# REVIEW OF US FILTER CORPORATION SALTON RIVER PROPOSAL FINAL REPORT

March 2003

**Salton Sea Authority**  
Plaza La Quinta  
78-401 Hwy 111, Suite T  
La Quinta, California 92253

**Tetra Tech, Inc.**

Figure 1. Graphic representation of proposal prepared by US Filter.

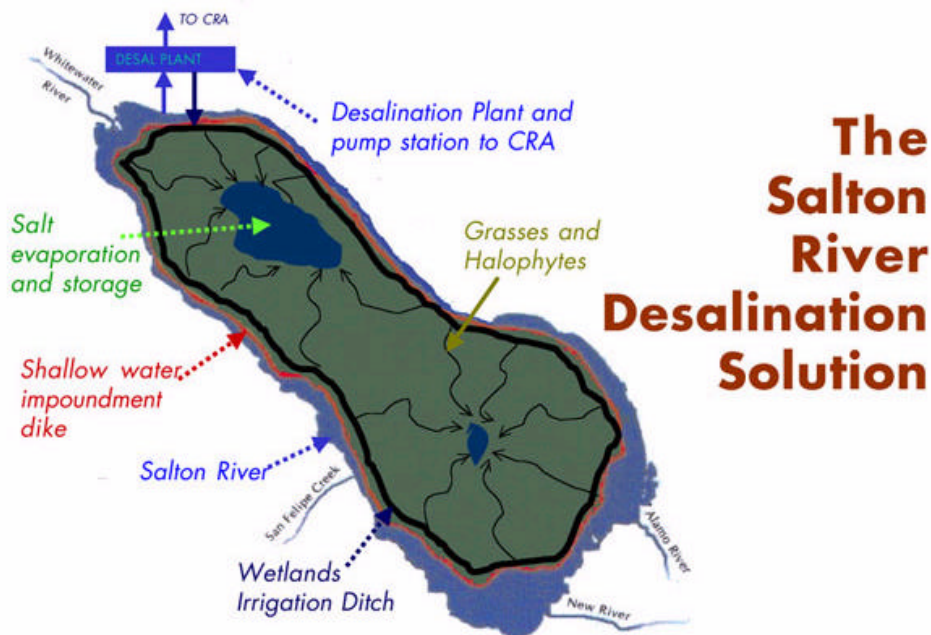
According to the US Filter Corporation website, the proposal, posted at <http://www.usfilter.com/water/water.asp?wid=593> would include the following components (see Figure 1 and Table 3):

- 1. 10-foot dike creates Salton "River" ring** - A shallow water 10-foot elevation dike that runs parallel to the entire shoreline of the Salton Sea would be built, creating a brackish area between the dike and the shore. The dike creates a 40,000-acre ring of water at the edge of the Salton Sea with a salinity level of approximately 3,000 ppm, far below the current salt content of 44,000 ppm. Excess water would overflow the dike into the central Sea.

Figure 2. Perimeter Sheet Pile Dike.

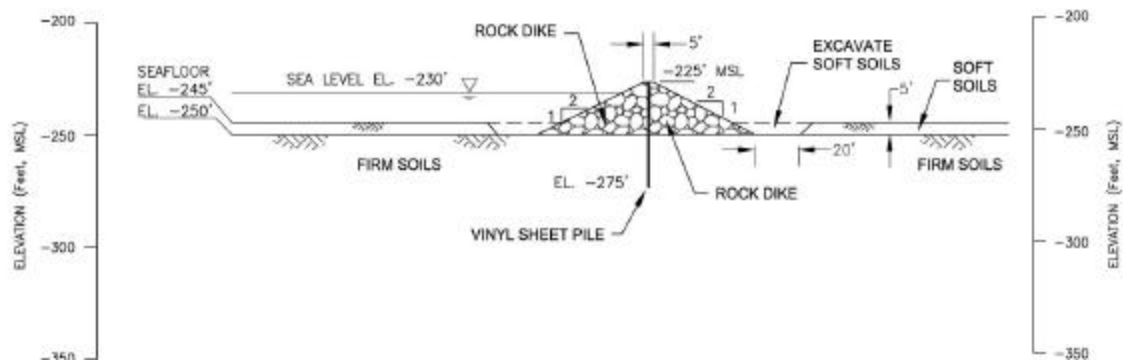
the dike includes a hydraulic barrier constructed of vinyl sheet piles. These sheet piles would be suitable for the lower hydraulic heads involved with the perimeter dike and would be corrosion resistant. The top of the sheet pile wall would be at elevation of -225 feet MSL to allow for the 5 feet of freeboard. For the base case, the dike would be constructed in 10 feet of water and a cost estimate was also prepared at 15 feet of water. The concept for the Salton Sea perimeter dike at a 15-foot water depth is shown in Figure 2. The concept for a 10-foot water depth would be similar.

The sheet pile wall would be buttressed with rock to provide stability. An over excavation of 5 feet of soft sediments below the seafloor was assumed. The rock would be placed by barge with side slopes of 2:1 and should be seismically resistant. A minimum crest width of five feet has been assumed. The length of the perimeter dike would be 94.5 miles at the -240 foot MSL contour (10 feet of water), and 92 miles at the -245 foot MSL contour (15 feet of water). It was assumed that a sheet pile embedment below the over excavation equal to the height of the dike as sufficient to mitigate potential piping failures. Overflow weirs could easily be incorporated into the dike by having the tops of the sheet piles at elevation -230 feet MSL at various locations around the perimeter.

Since the Salton Sea is located in a highly seismic area, estimates have been included in the cost evaluation to provide for routine maintenance as well as rebuilding of the dike structures should they be damaged by earthquake activity.

Figure 3. Predicted Salinity with Inflow Reduced to 1,000,000 Acre-Feet per Year.

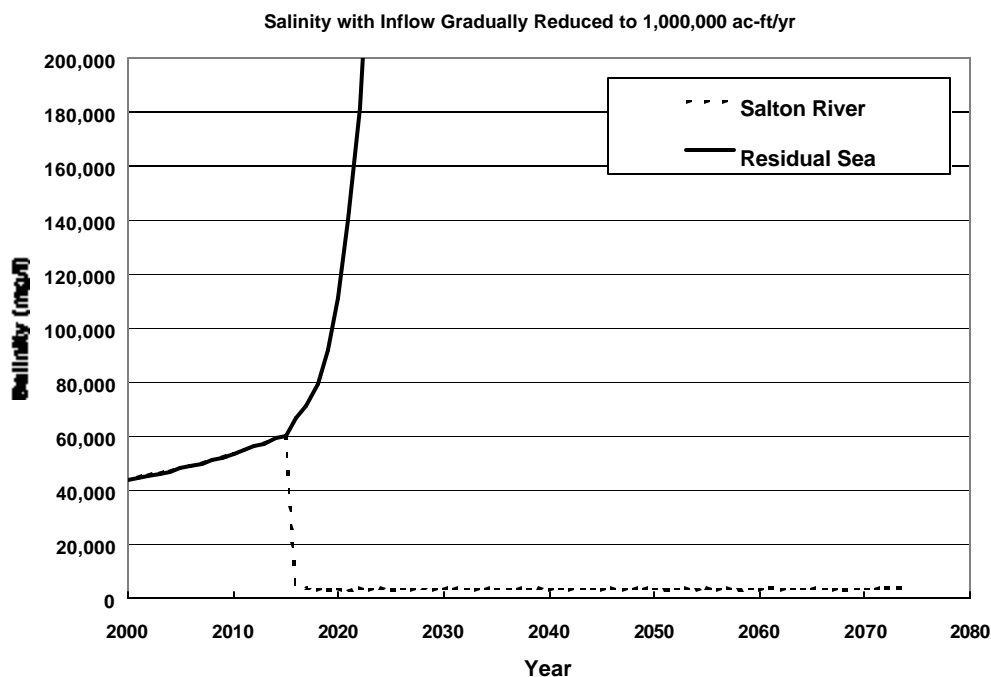
The Bureau of Reclamation's Salton Sea Accounting model was adapted by Reclamation to evaluate the salinity and elevation for the US Filter proposal. Figure 3 illustrates the projected salinity both within the proposed Salton River impoundment and in the residual Sea. The model shows that upon completion of construction, the salinity in the impoundment is projected to rapidly decrease to about 4,000 mg/L, while the residual Sea would rapidly become hypersaline and would become saturated with salts in only a few years.

Certain factors could cause the salinity of the inflows to increase. These include reduction of low salinity tailwater runoff from agricultural fields, and reduction in input of low salinity municipal wastewaters from Mexicali (if and when Mexico chooses to reclaim this water). Salinity of Whitewater River (Coachella Valley Flood Control Channel) inflows could increase slightly over time if additional amounts of Colorado River water are transferred to the Coachella Valley, in part to replenish its aquifer. Taking all these factors into account, it is predicted that the Salton River impoundment would within a few months achieve an equilibrium salinity level of about 4,000 mg/L.

The predicted equilibrium salinity level of about 4,000 mg/L is of particular biological significance. Limnologists conventionally set 3,000 mg/L as the dividing line between fresh and brackish waters. This is not entirely arbitrary. Most of the world's fresh waters have salinity less than 1,000 mg/L and most of its inland saline waters have salinity greater than 5,000 to 10,000 mg/L. The nature of lake biota correspondingly changes rather abruptly as one goes from 1,000-2,000 mg/L to 6,000-8,000 mg/L. Slight differences in this salinity range can cause large changes in the nature of the system, and much larger changes than might be produced by going from, say, 8,000 mg/L to 20,000 mg/L. Some species of aquatic vascular plants that would colonize the impoundment would find themselves near the upper limits of their salinity tolerance.

Figure 4. Graphics Depicting Residual Sea.

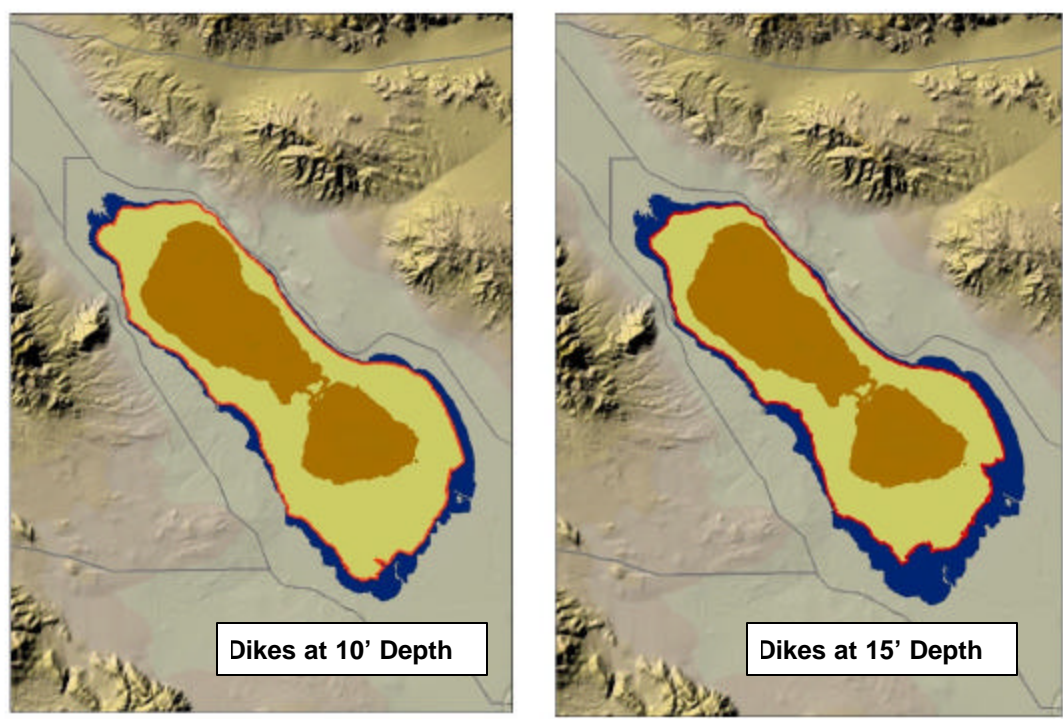
100,000 acres (less than 160 square miles). As shown in Figure 4, the resulting Sea would be more than 200 square miles smaller than the current Sea. If the dikes were constructed in 10 feet of water, about 190 square miles of sediments would be exposed between the dikes and the residual Sea. If the dikes were constructed in 15 feet of water, about 160 square miles of sediments would be exposed between the dikes and the residual Sea.

**Figure 5. Conceptual Layout for North Lake Alternative.**

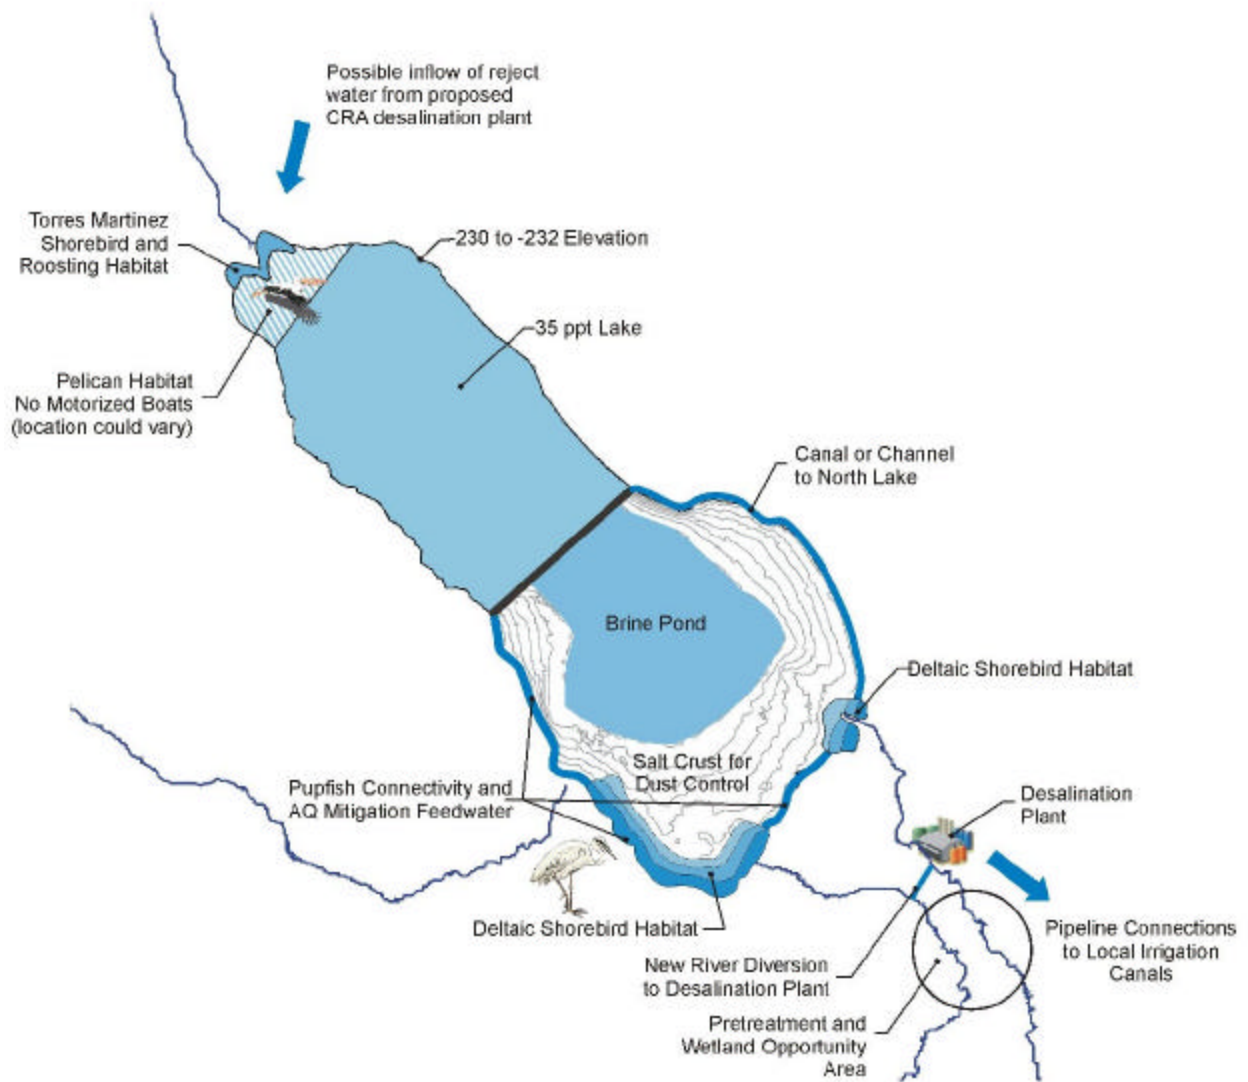
The North Lake alternative is illustrated on Figure 5. This variation would involve constructing the treatment plant at the south end of the Sea instead of the north, a mid-Sea dam, and only enough dikes to convey water from the south end of the Sea to just north of the dam. The North Lake would be sustained at an elevation of about -230' msl and at a salinity of 35,000 mg/L.

- Shorebird and pupfish ponds in the southern area would provide bird habitat and connectivity of pupfish habitat. However, while this alternative addresses some bird habitat issues, key foraging and resting areas for all wading species in the south end of the Sea would not be addressed and only one of three key areas at the north end, the Whitewater Delta/Torres Martinez Shorebird and Roosting Habitat would be addressed. The deltaic shorebird habitats at the south end of the Sea, and the Torres Martinez habitat plan at the north end as proposed in this alternative appear to be subject to the same physical conditions and to encroachment by vegetation, as does the base proposal. The vast majority of breeding colonies of waterbirds are located at the south end of the Sea in patches of dead tree snags or on small islets isolated by water from the shoreline. Loss of these sites could occur under this alternative, and modifications should be considered during more detailed design phases to address these issues.

P. 34, Fig 5. While Variation 1 addresses a few bird habitat issues, key foraging and resting areas for all wading species in the south end of the Sea are not adequately addressed and only one of three key areas at the north end, the Whitewater Delta/Torres Martinez Shorebird and Roosting Habitat is addressed. The deltaic shorebird habitats at the south end of the Sea, and the Torres Martinez habitat plan at the north end as proposed in Variation 1 appear to be subject to the same physical conditions and to similar or perhaps even greater rates of encroachment by vegetation, as does the base proposal. The vast majority of breeding colonies of waterbirds are located at the south end of the Sea in patches of dead tree snags or on small islets isolated by water from the shoreline (see Fig. 4-6, Shuford et al. *Avifauna of the Salton Sea*). The loss of these sites that would apparently occur under Variation 1 is not considered by this proposal, nor is it adequately addressed by this review.

Figure 6. Conceptual Layout for Variation to the US Filter Proposal.

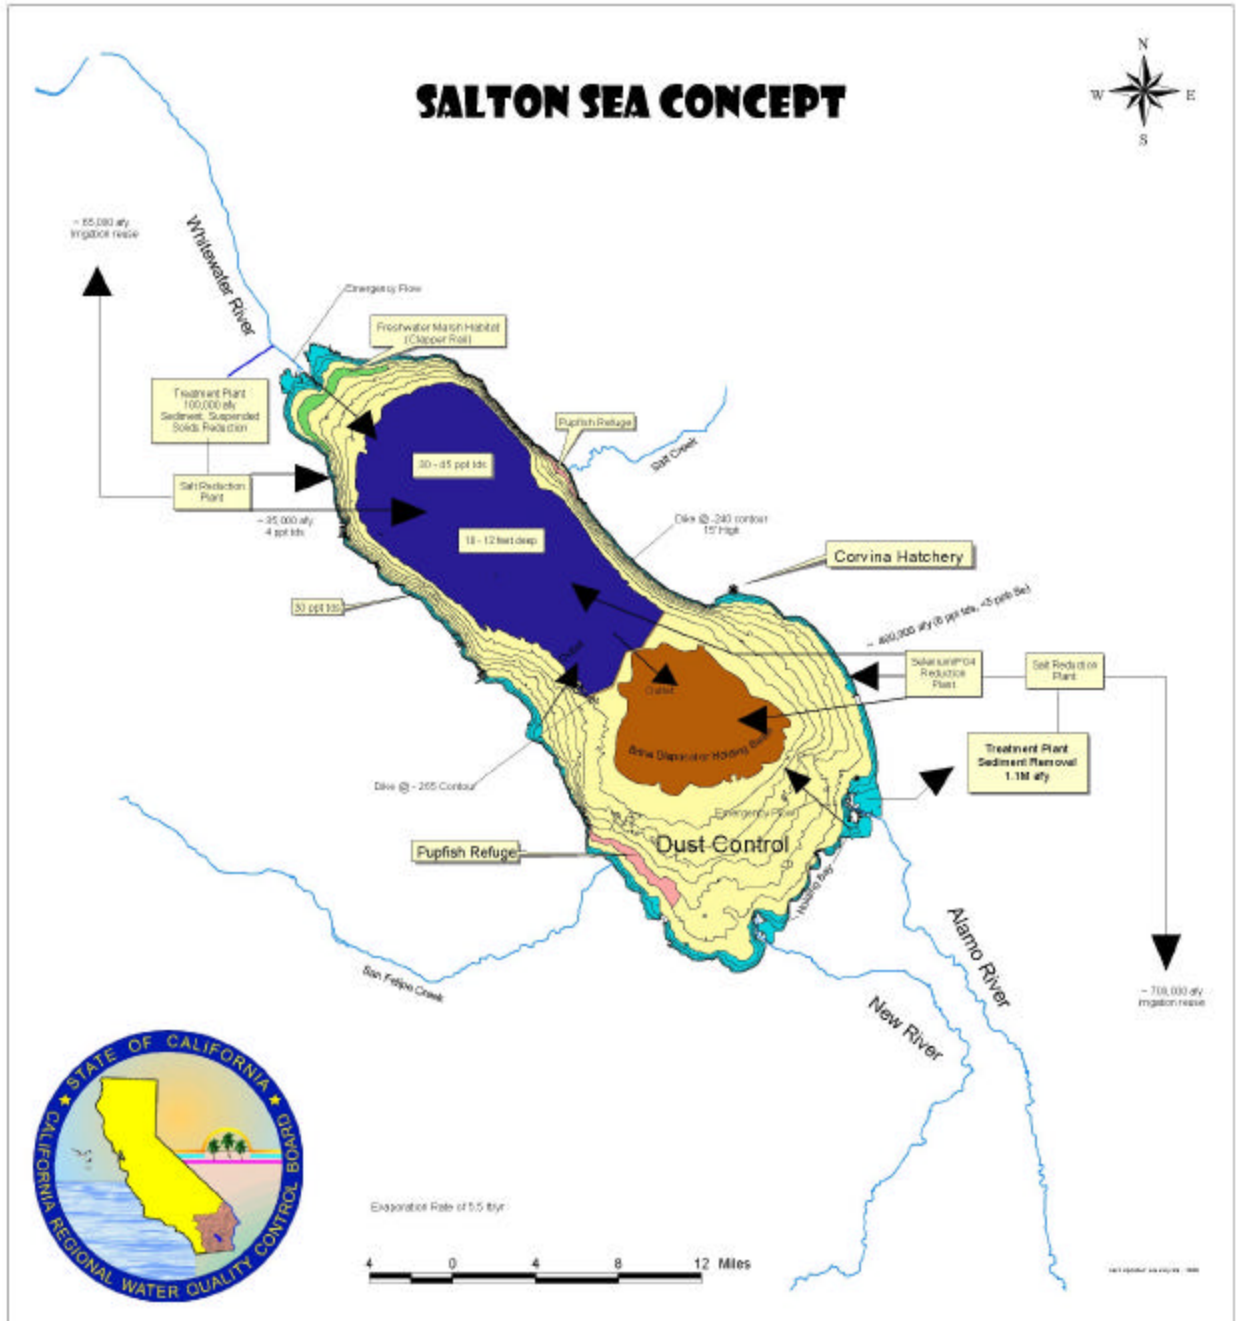
This variation, illustrated in Figure 6, would involve the following differences from the base US Filter proposal:

This variation to the US Filter proposal would allow several cost savings in eliminating the piping and pumping costs to the Colorado River Aqueduct. In addition, the mid-Sea dike would be considerably less expensive than that proposed for North Lake alternative. Other added features would add cost such that the estimated cost of producing water for this variation is expected to be about 25 percent greater than for the basic US Filter proposal.

A technical challenge for this alternative would be creating the marine fishery in the north basin. After creation of the peripheral dikes and construction of the primary treatment plant, the residual Sea would begin to shrink rapidly. This residual Sea would rapidly become hypersaline and salts would begin to

P. 39, Fig. 6- Variation 2. The retention of a marine environment in the central impoundment and in the Salton River impoundment may provide higher quality habitat for waterbirds and shorebirds, respectively, than those schemes proposed in the base and Variation 1 versions. However, from the information provided it is unclear how water depth could be effectively controlled in the narrow, peripheral band of the Salton River, to maintain adequate areas for shallowly flooded (0-10 cm of water) mudflats suitable for shorebird foraging and waterbird roosts. The loss of all existing breeding colony sites of waterbirds is not considered in this proposal (see Fig. 4-6, Shuford et al. Avifauna of the Salton Sea), and inadequately addressed by this review.

Figure 7. Conceptual Layout for Variation to the North Lake Proposal.

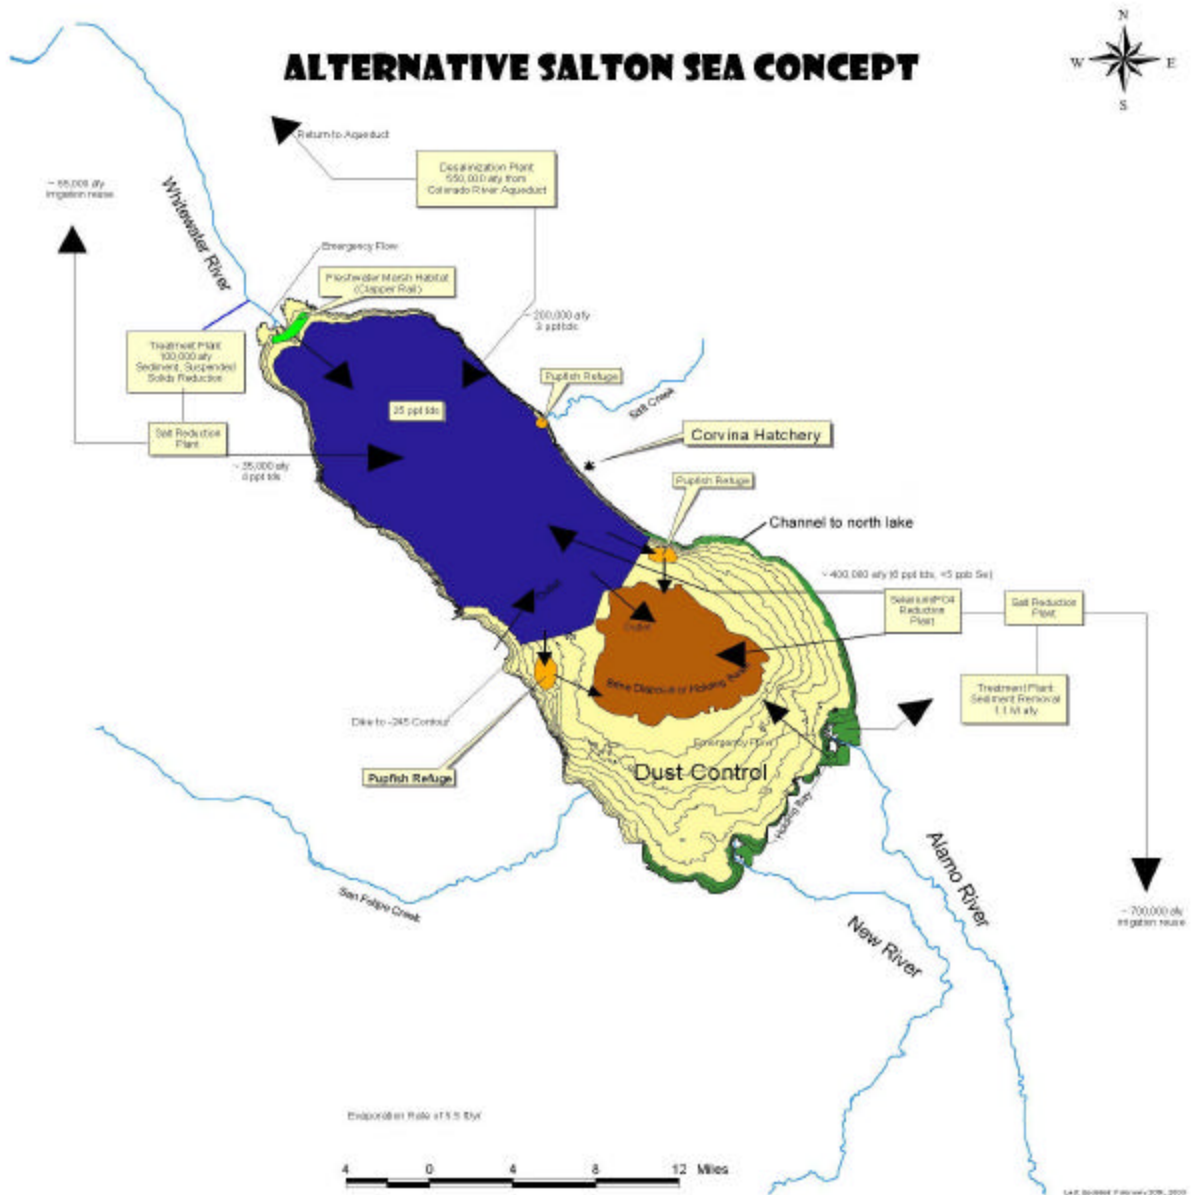
Since the first draft of this report was prepared, the RWQCB has proposed the variation to the North Lake shown in Figure 7. The northern lake component would offer the same advantages over the Salton River concept as those discussed for the North Lake alternative. However, the lake would be about 15

feet lower than the current elevation of the Salton Sea. It is likely that this reduced elevation would be unpopular with local residents. The lower lake level would save costs on the dam construction, and make the dam height lower and less susceptible to seismic failure. Some additional water quality improvements features are included in this variation. The additional cost of these features may offset the savings associated with a lower dam height, so that the costs would be comparable.

At the current conceptual level of analysis, this variation is similar enough to the North Lake alternative to make distinguishing comments difficult. It does, however, offers some variations that are worthy of further considerations should a more detailed engineering analysis and design be conducted.

Fig. 2. Wind-mixed depth as a function of windspeed and fetch.

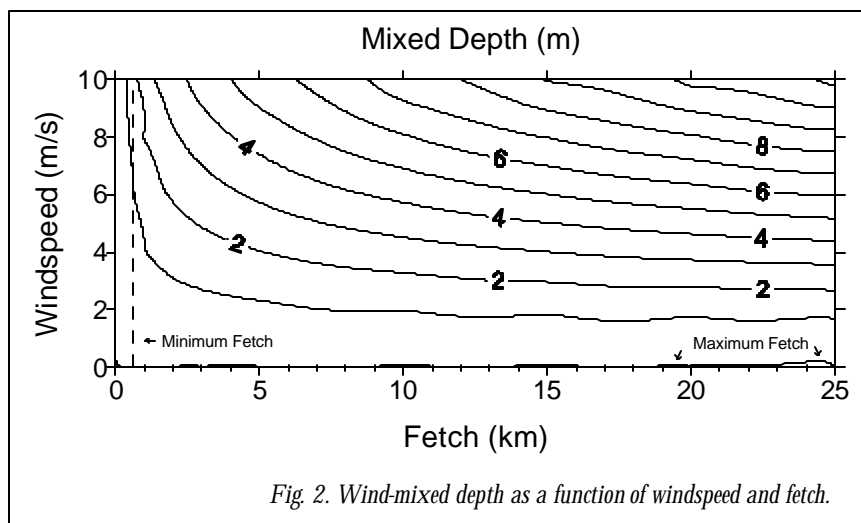
respectively, typical afternoon-evening winds are expected to be able to mix the water column quite readily. That is, wind speeds of about 4 m/s would be sufficient to routinely mix heat and DO down to >2 m depth. In fact, simple empirical relationships indicate that the thermocline depth is about 2x the mixed layer depth. Thus, heat and DO can be expected to mix throughout the water column under both the 10 ft and 15 ft dike options; strong anoxia is unlikely to be a chronic problem in the system. This will be different than the current conditions at the Sea, where several months during the late spring and summer are characterized by negligible DO in the lower portions of the water column.

This will also change the biogeochemistry of the surficial sediments, since anoxia and strong sulfate reduction will be replaced by largely aerobic processes. The current biogeochemical reaction posited to help restrict SRP release from the sediments (alkalinity production from the sulfate reduction reaction, with concomitant coprecipitation of SRP with  $\text{CaCO}_3$ ) will likely be lost. That is, lower  $\text{Ca}^{2+}$  and  $\text{SO}_4$  concentrations due to the lower salinity, combined with aerobic conditions, will reduce substantially this reaction. Will the traditional  $\text{Fe}(\text{OH})_3$  phase found to regulate SRP flux ultimately control internal loading in the Salton River? That mechanism could be more or less effective than the hypothesized mechanism thought to be operating currently, so internal loading may or may not be higher in the Salton River. Moreover, hydraulic flushing will be removing a substantial amount of nutrients, perhaps at a level comparable to that we feel is being buried with  $\text{CaCO}_3$  each year currently.
